**TOWNSHIP OF SOUTH WHITEHALL
LEHIGH COUNTY, PENNSYLVANIA**

PLANNING COMMISSION

FEBRUARY 18, 2021

A G E N D A

SITE PLAN

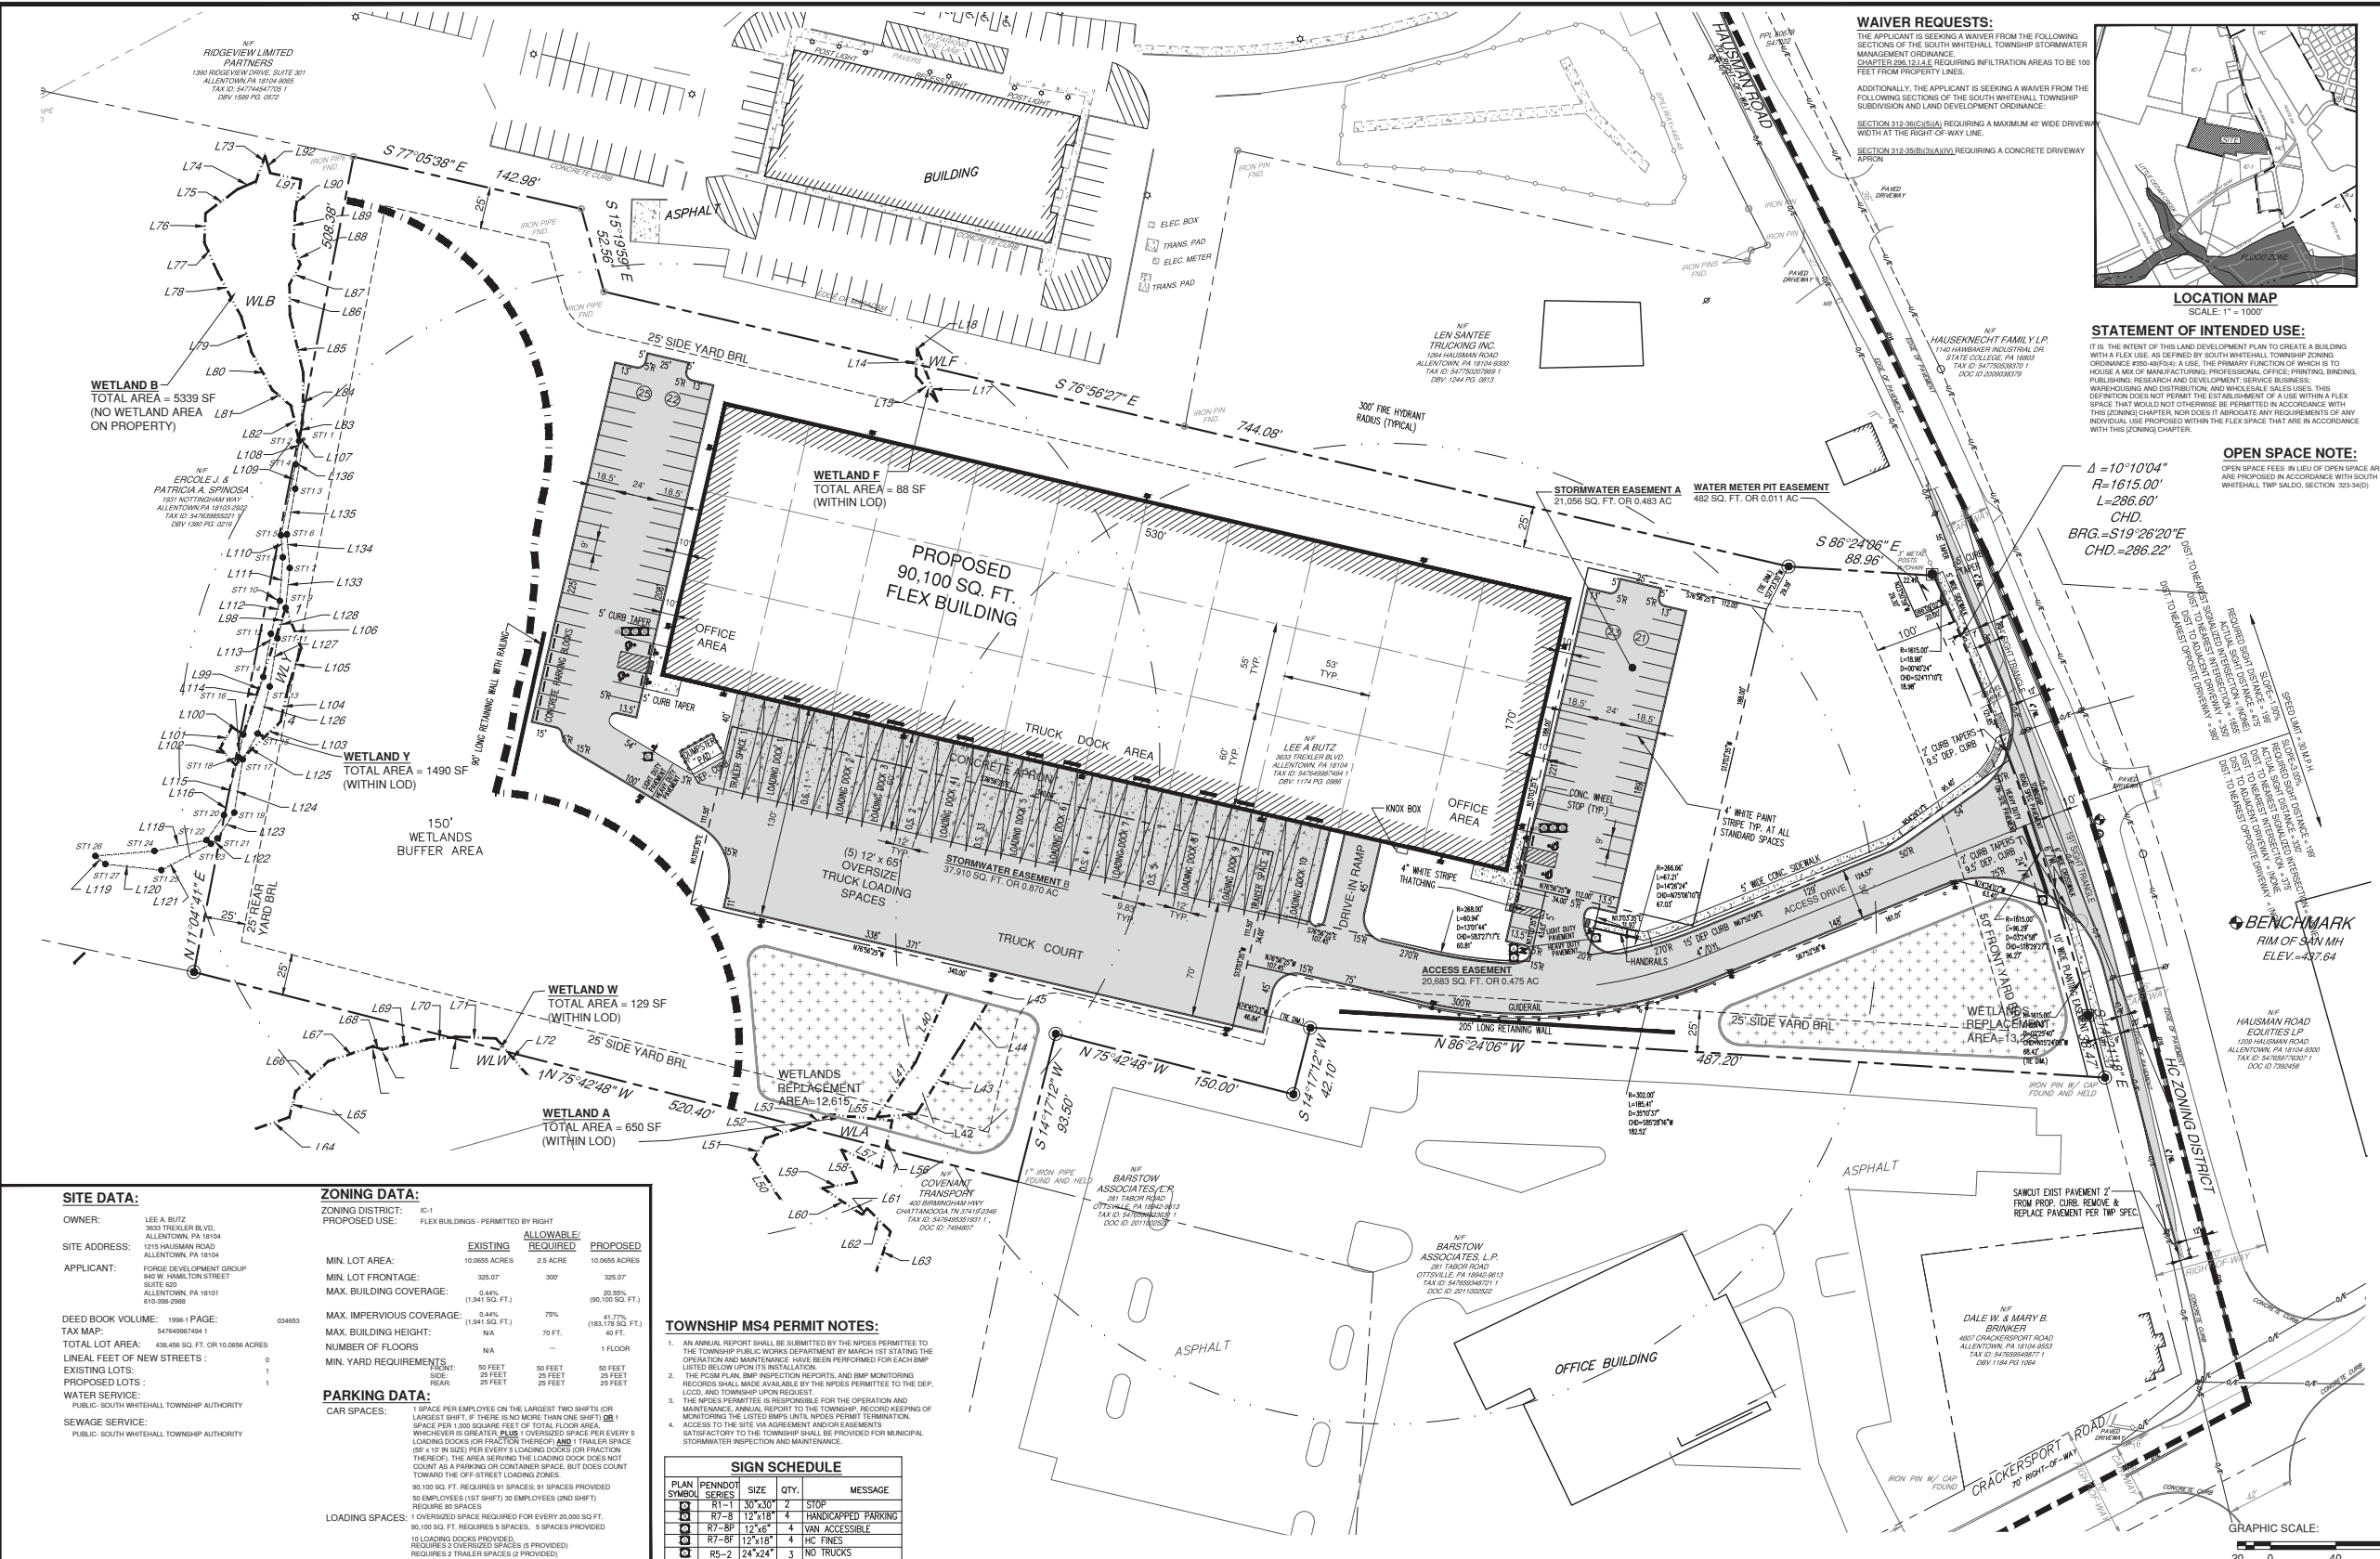
Site Plan, Sheet 4, the area of the "truck court" is showing a side yard setback of approximately five (5') feet. A variance is required from the required twenty-five (25') foot side yard setback.

The general parking criteria, Section 350-48(o) and Section 350-48(o)(2), has been utilized for this plan on Sheet 4, and shall be noted on the plan under the Zoning Criteria on Sheet 4, and as applicable elsewhere. Since a specific use or tenant has not been determined at this time, a Note shall be added to the Record Plan that each individual tenant must apply for permits for their zoning use.
